CP-202000312  
TXX-20042  
May 12, 2020

Subject: Comanche Peak Nuclear Power Plant (CPNPP)  
Docket Nos. 50-445, 50-446  
Transmittal of Revised Emergency Plan (Revision 43)

### Comanche Peak Nuclear Power Plant Emergency Plan Revision 43 (Effective April 16, 2020) - changes made without prior NRC approval.

COMANCHE PEAK NUCLEAR POWER PLANT <b>EMERGENCY PLAN</b>
EMERGENCY ORGANIZATION
JOINT INFORMATION CENTER
FIGURE 1.6

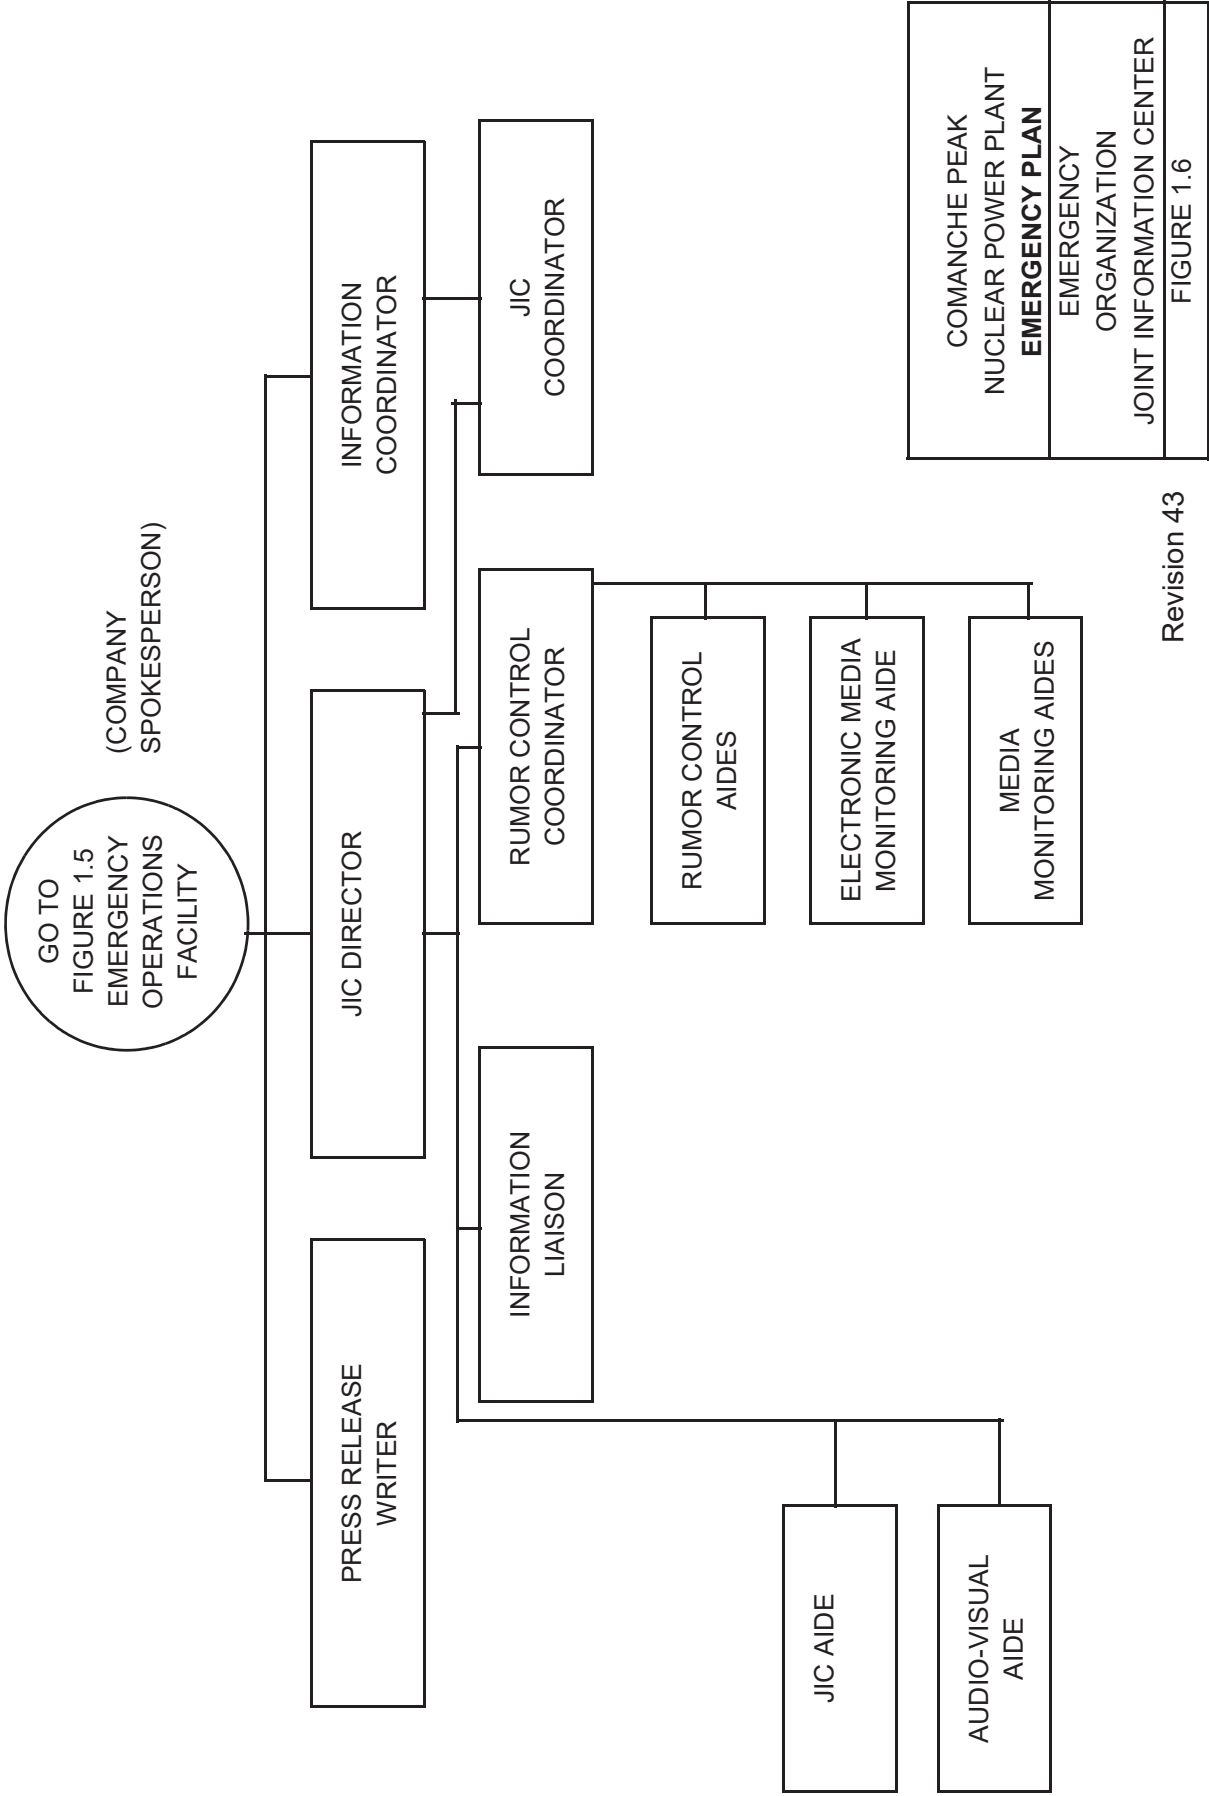
- Throughout the plan, update the licensee name from "Luminant" to "Vistra Operations Company LLC (Vistra OpCo)."
- Change "Houston Lighting and Power" to "South Texas Project" in Sections 1.2.3 and 6.8; to reflect the current plant name.
- Revise Figure 1.6 to read "Electronic Media Monitoring Aide" instead of "Electronic Media Monitoring Aides" (singular instead of plural).

- Change the company name from Luminant to Vistra Operations Company LLC (Vistra OpCo).
- Revise Sections 1.2.3 and 6.8 to "South Texas Project" from "Houston Lighting and Power."
- Change Figure 1.6 to "Electronic Media Monitoring Aide" (instead of "Aides").
